CITY OF GLENDALE, CA

DESIGN REVIEW STAFF REPORT – SINGLE FAMILY

July 10, 2024 <i>Hearing Date</i>	4341 Boston Avenue <i>Address</i>
Administrative Design Review (ADR) <i>Review Type</i>	5604-007-041 <i>APN</i>
PADR-003097-2024 <i>Case Number</i>	Sepou Ohanian <i>Applicant</i>
Eric Ji, Planning Associate <i>Case Planner</i>	Sepou Ohanian <i>Owner</i>

To add a new 758 square-foot (SF) second story and add 790 SF to the first floor of an existing one-story, 964 SF house (built in 1952) with an attached 400 SF 2-car garage on an 8,050 SF lot zoned R1 (Floor Area District II).

Landscape Area Calculation

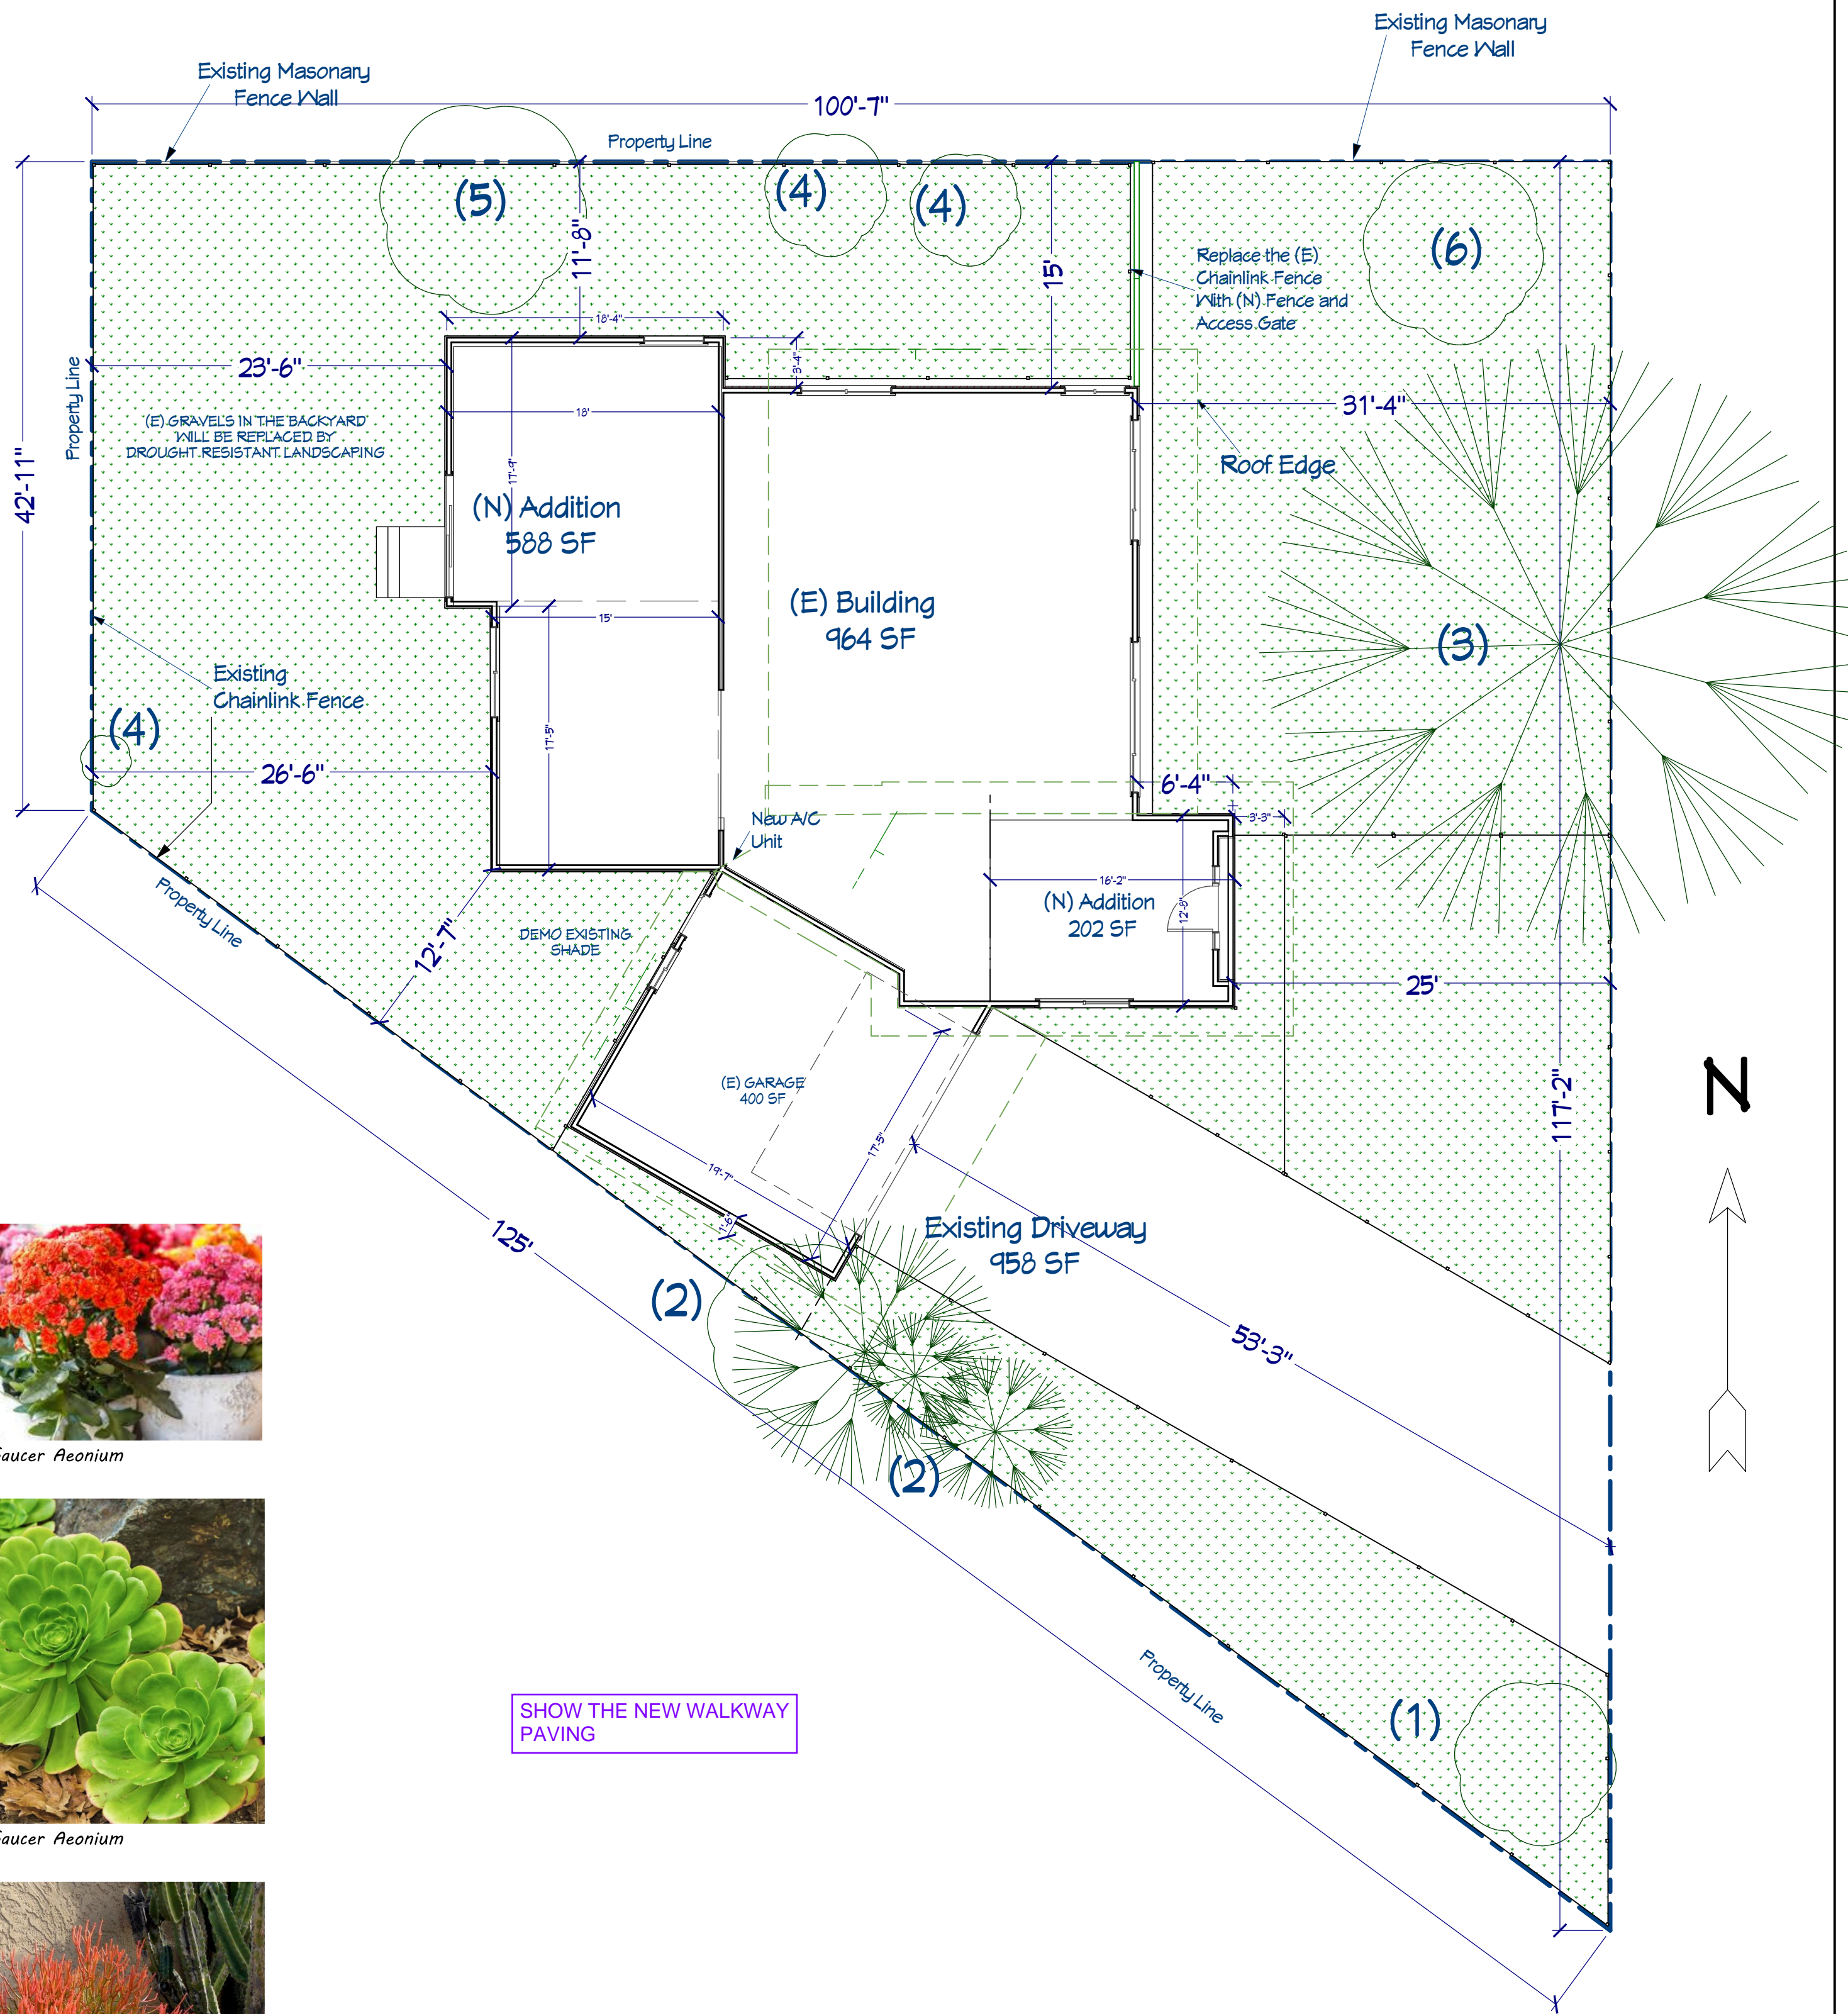
SHOW THE NEW WALKWAY PAVING
